THE VILLAS AT CLAREMONT RANCH

STREET IMPROVEMENTS PLANS

THE VILLAS AT CLAREMONT RANCH

STORM SEWER PLANS

THE VILLAS AT CLAREMONT RANCH
CONSTRUCTION DRAWINGS
STREET IMPROVEMENT DETAILS

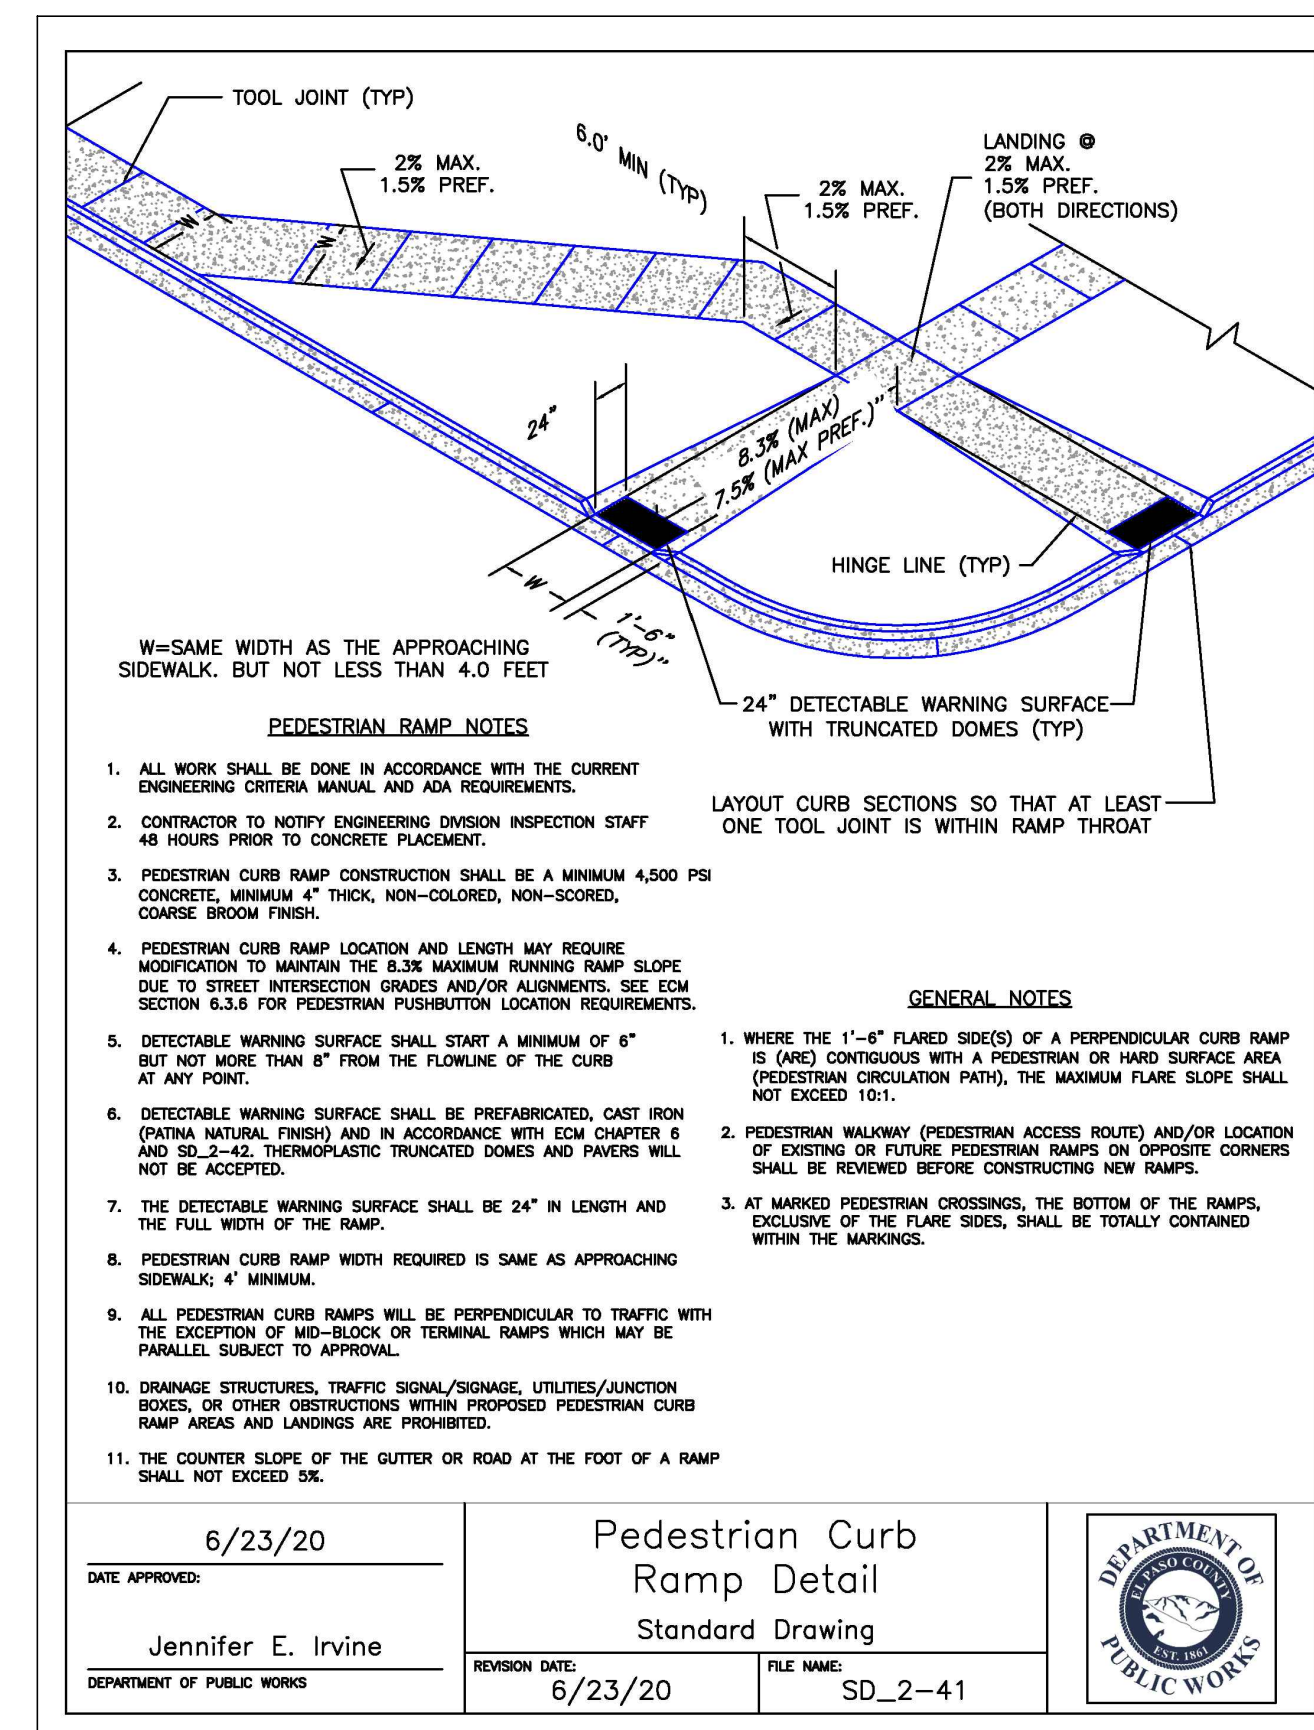
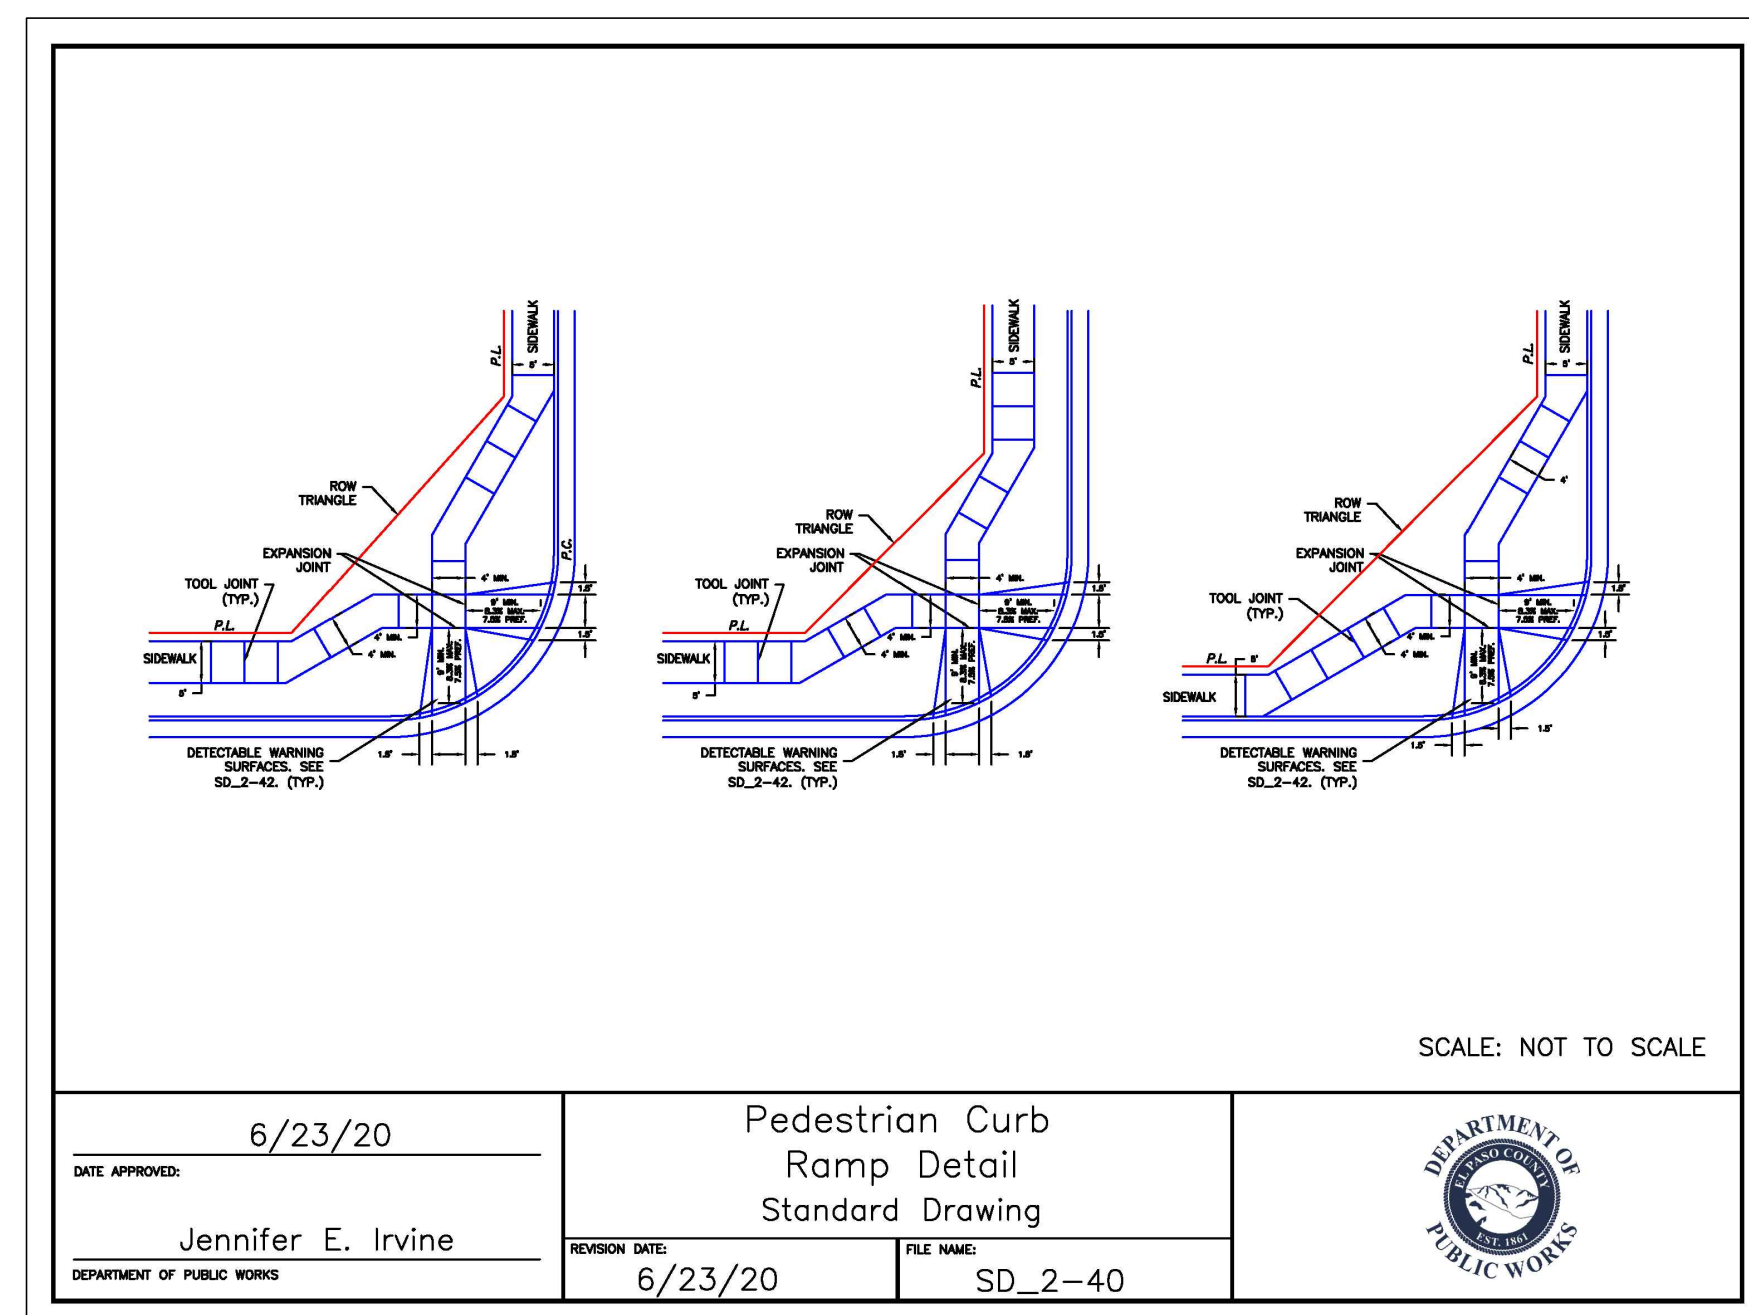
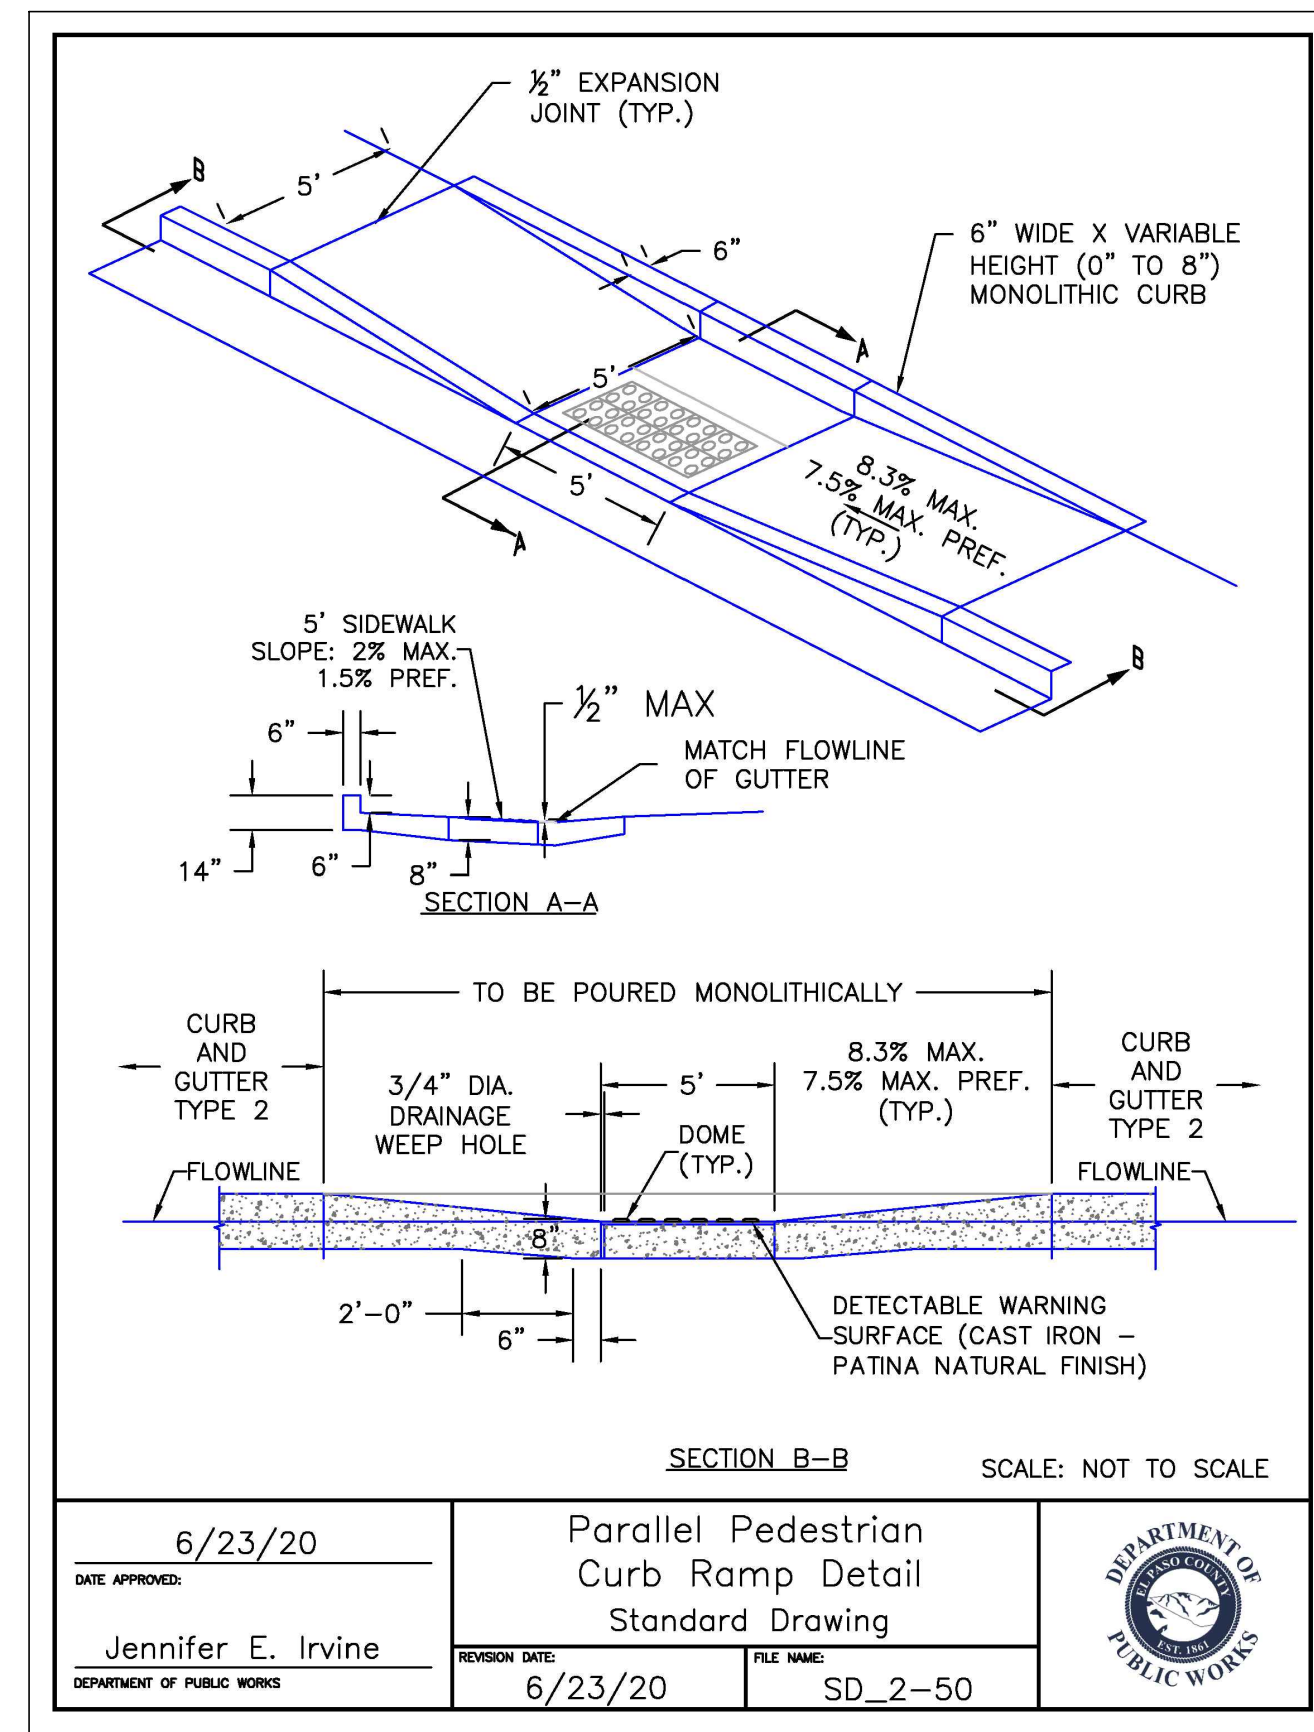
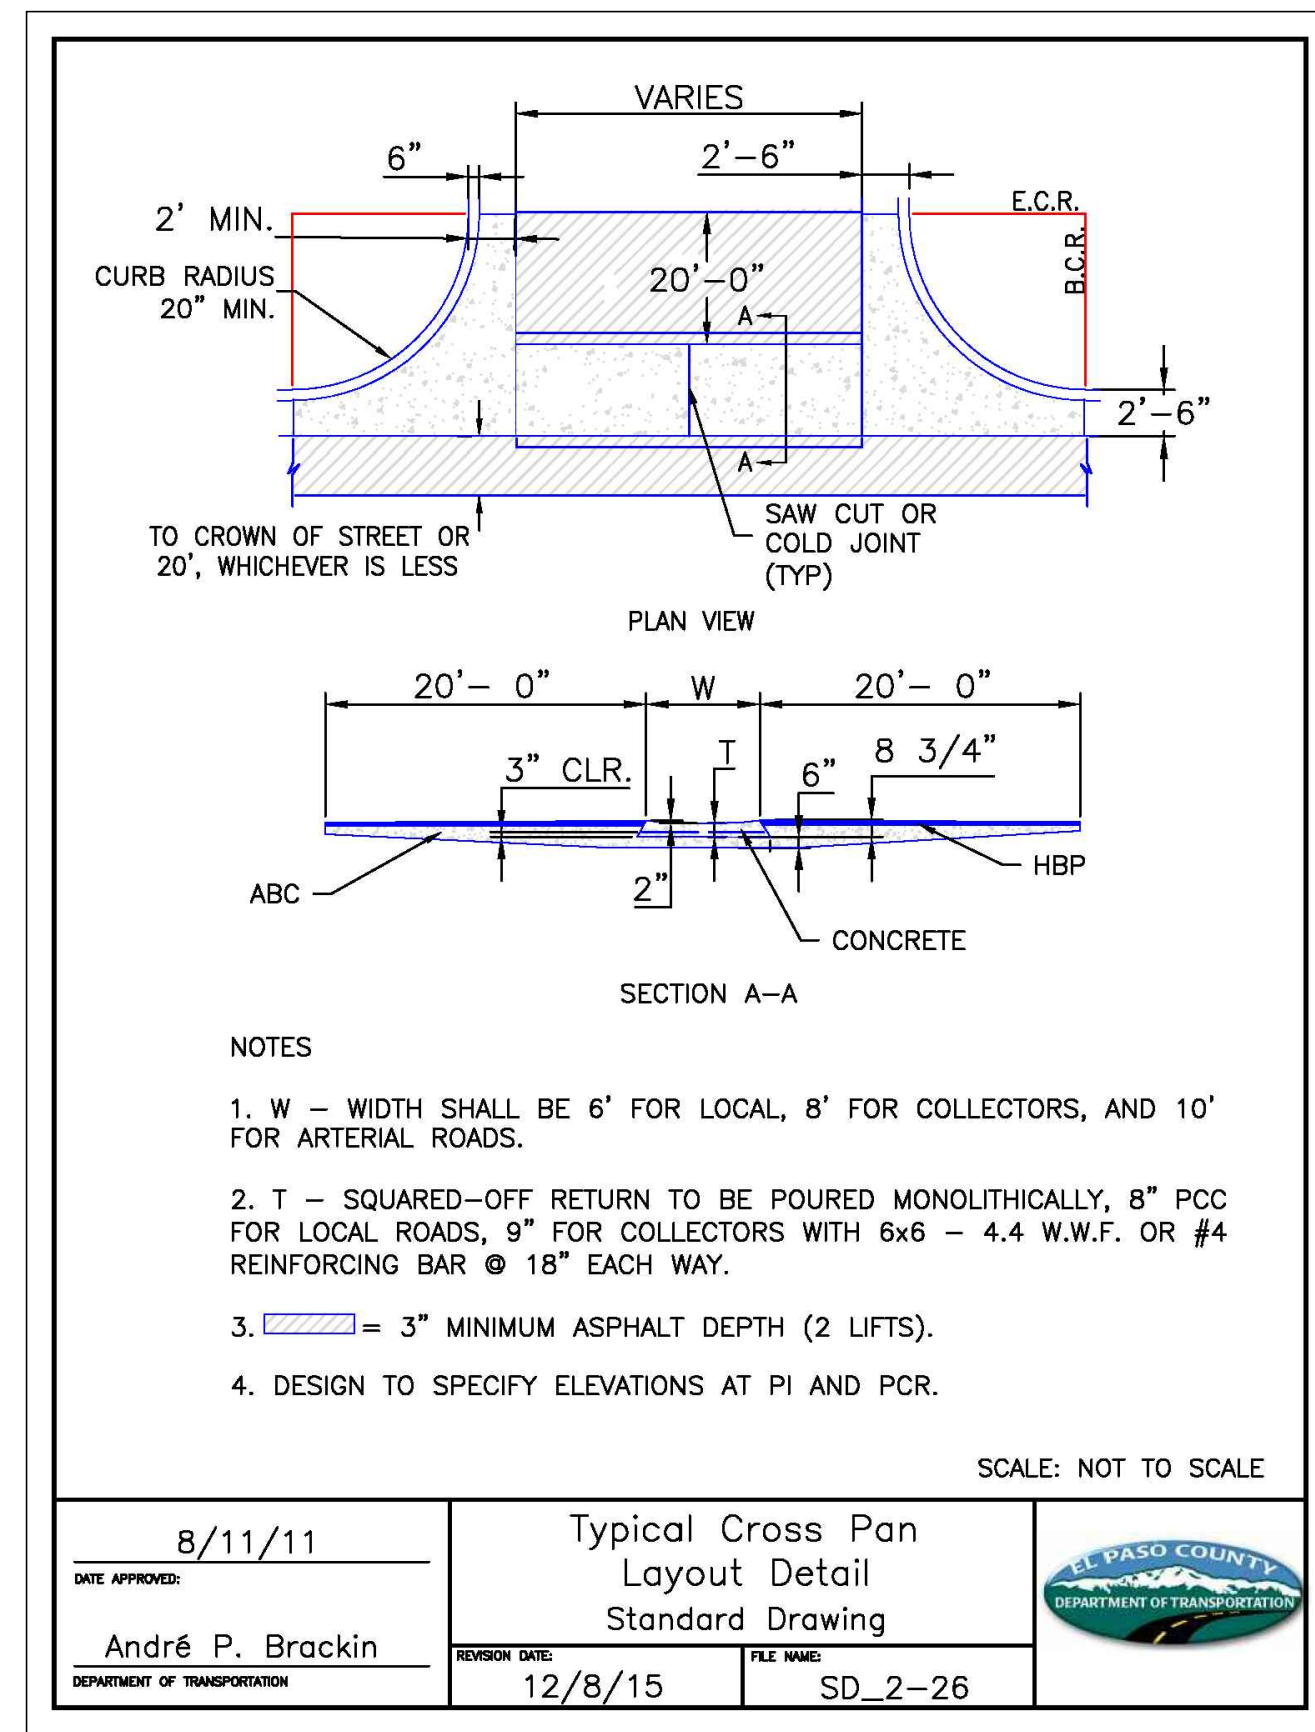
Add curb transition detail
